MEMORANDUM

From:	Tina Cuss Ecology Officer		
Service	WBC Ecology	App No:	261182
Address:	12 South Drive, Sonning, Wokingham, RG4 6GB.		
Proposal:	Householder application for the proposed erection of a two storey front and side extension, part single storey part two storey rear extension, single storey rear extension with pitched roof, erection of terrace, garage conversion to create habitable accommodation plus changes to fenestration and erection of front gates.		
Type of Development:	Other Householder		
Site Visit Made:	No

Figure 1. Preliminary Roost Assessment findings plan.

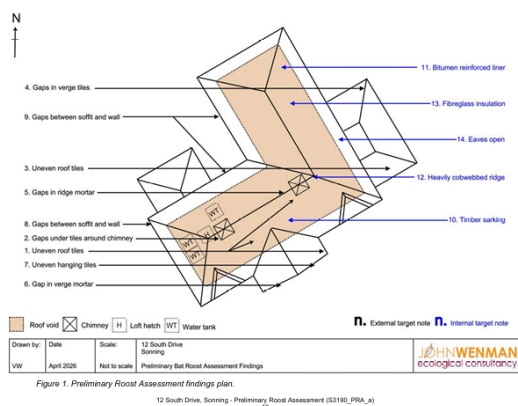
The PRA inspection potential roost features including raised and uneven roof tiles, gaps in ridge and verge, gaps behind uneven hanging tiles and between overhanging timber eaves and walls. While the Ecologist states that their desk study included pre-existing bat survey reports, they did not assess the record of pipistrelle bats emerging from 12 South Drive recorded by Hampshire Ecological Services in 2019 submitted in support of application 200757.

Bat emergence surveys were completed on 19 May, 17 June and 09 July 2026 in general accordance with the Good Practice Guidelines. During the first survey 1 Common pipistrelle emerged at 21.02 from the timber frame on the front elevation, 1 Soprano pipistrelle emerged from the hanging tiles on the southern gable and a single Common pipistrelle emerged at 21.34 from Roost A on the front elevation. Bat activity was high during all three dusk surveys. 89 passes were recorded from at least 7 different species of bat during the second and 101 passes from 6 species in the third dusk survey. I agree that Roost A and Roost B are likely to be small day roosts, but I am concerned that the Ecologist's assessment of site status did not also take account of pipistrelle roosts recorded by Hampshire Ecological Services. Contrary to my recommendation GS Ecology have not completed a local bat group or TVERC data search and appear not to have been aware that Pipistrelle bats were recorded emerging from 12 South Drive.

I agree Bat Survey section 4.6 that as both bat roosts will be lost a licence from Natural England for development works affecting bats will need to be obtained before the works commence.
